STATE OF FLORIDA DEPARTMENT OF TRANSPORTATION
WATER QUALITY IMPACT EVALUATION CHECKLIST

Project Name:	US 301 (SR 41) PD&E Study
County:	Hillsborough & Pasco
FM Number:	255796-1-22-01
Federal Aid Project No:	N/A
Brief Project Description:	The Florida Department of Transportation (FDOT), District Seven, is conducting a Project Development and Environment (PD&E) Study for the proposed improvements to US 301 from Fowler Avenue (SR 582) in Hillsborough County to SR 56 in Pasco County. The total project length is approximately 13.1 miles. The proposed action includes widening US 301 from two lanes to four lanes and providing pedestrian and bicycle accommodations.

RE: US 301 PD&E from Fowler Avenue to SR 56; FPID 255796-1-22-01; Longlist Pond Siting Meeting

US 301 from Fowler to County Line Area Proposed Stormwater Projects

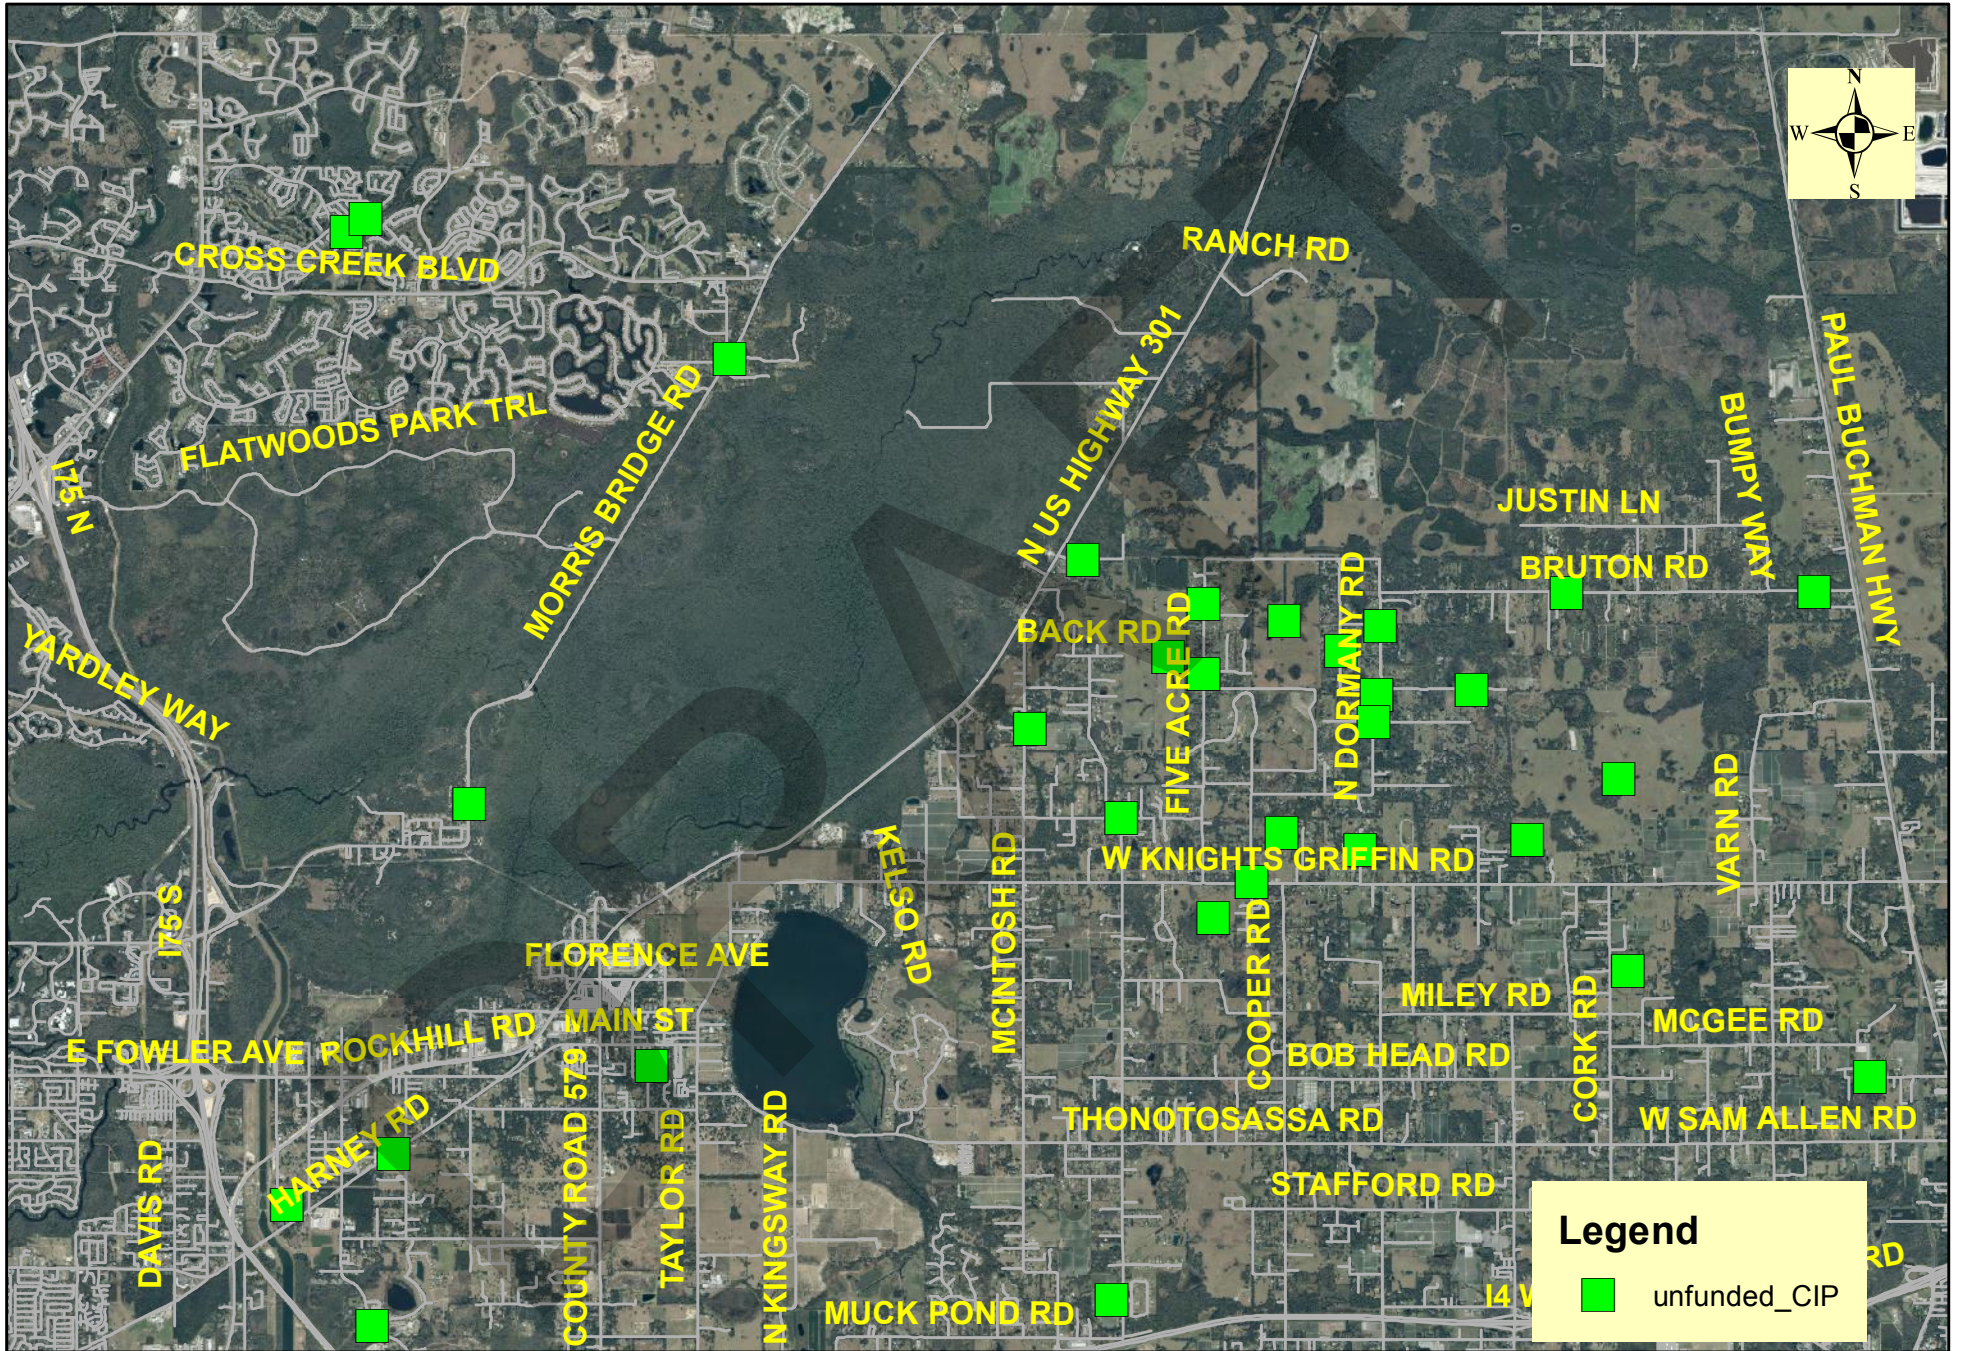
Attached please find a map showing the proposed stormwater projects in this area.
